BID FOR: Edenborn Avenue Drainage Improvements
(18th Street to West Esplanade Avenue)
Public Works Project No. 2010-054-DR
Proposal No. 50-00116795

EDENBORN AVENUE DRAINAGE IMPROVEMENTS
(18TH STREET TO WEST ESPLANADE)
PW NO. 2010-054-DR
PROPOSAL NO. 50-00116795
PRE-BID MEETING MEMORANDUM
A/E PROJECT NO. 20-1334 JULY 12, 2016

SCHEMATIC WATER METER MANIFOLD DETAIL

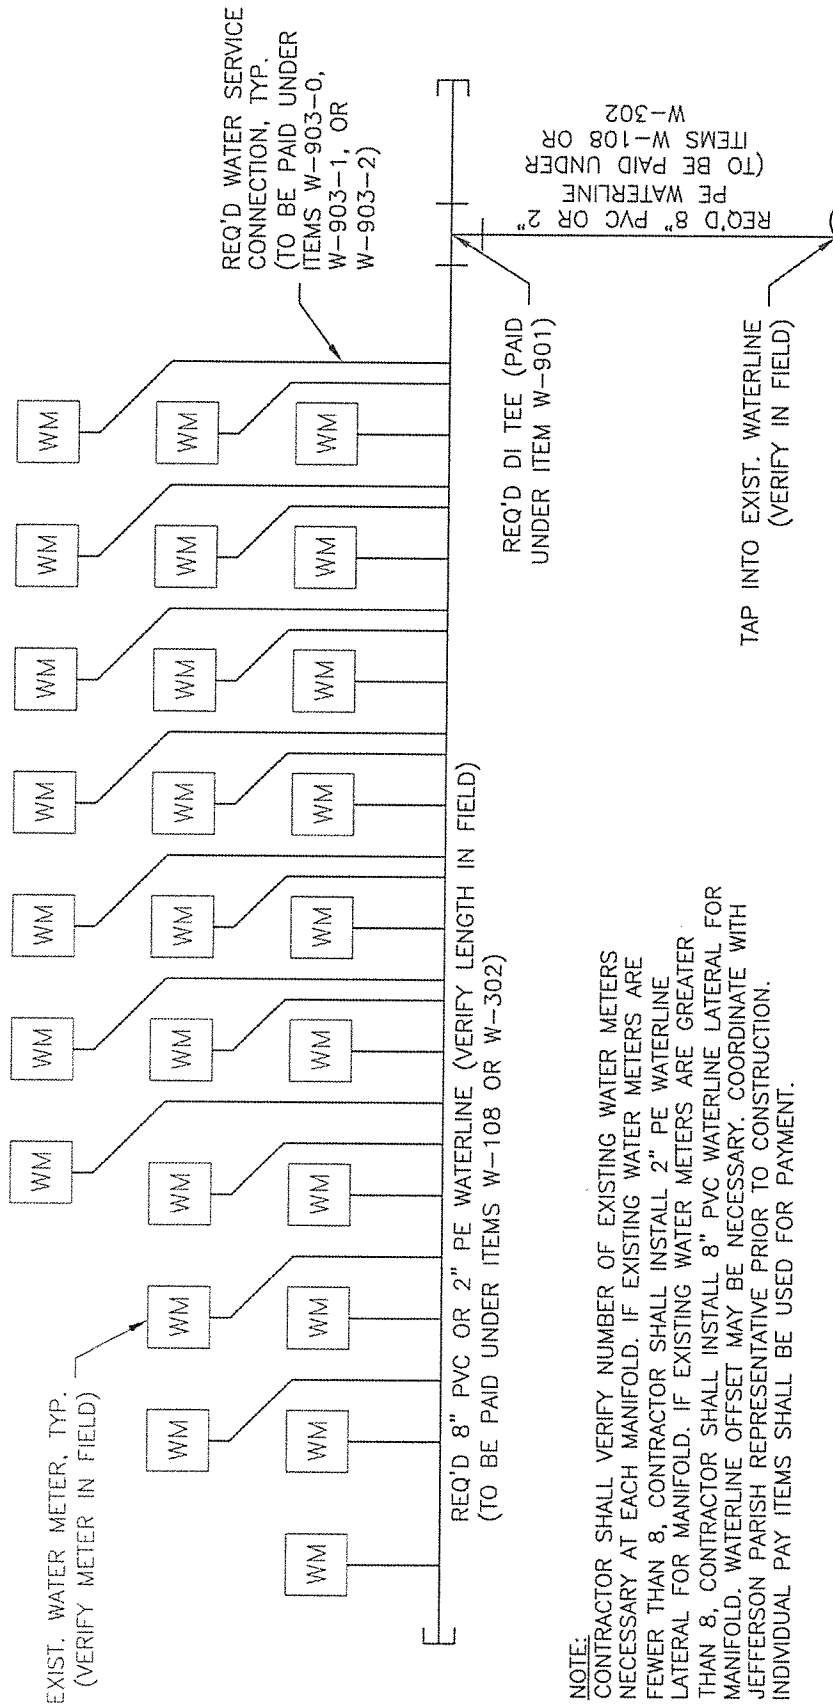
- AD1.6 Drawings, Sheet No. 9, Miscellaneous Details, Detail No. 7, Schematic Water Meter Manifold Detail. Delete this detail in its entirety and replace with Sketch SK1, Detail No. 7, Schematic Water Meter Manifold Detail numbered ADDENDUM NO. 1 – PAGE 46.

NOTE:
 CONTRACTOR SHALL VERIFY NUMBER OF EXISTING WATER METERS NECESSARY AT EACH MANIFOLD. IF EXISTING WATER METERS ARE FEWER THAN 8, CONTRACTOR SHALL INSTALL 2" PE WATERLINE LATERAL FOR MANIFOLD. IF EXISTING WATER METERS ARE GREATER THAN 8, CONTRACTOR SHALL INSTALL 8" PVC WATERLINE LATERAL FOR MANIFOLD. WATERLINE OFFSET MAY BE NECESSARY. COORDINATE WITH JEFFERSON PARISH REPRESENTATIVE PRIOR TO CONSTRUCTION. INDIVIDUAL PAY ITEMS SHALL BE USED FOR PAYMENT.
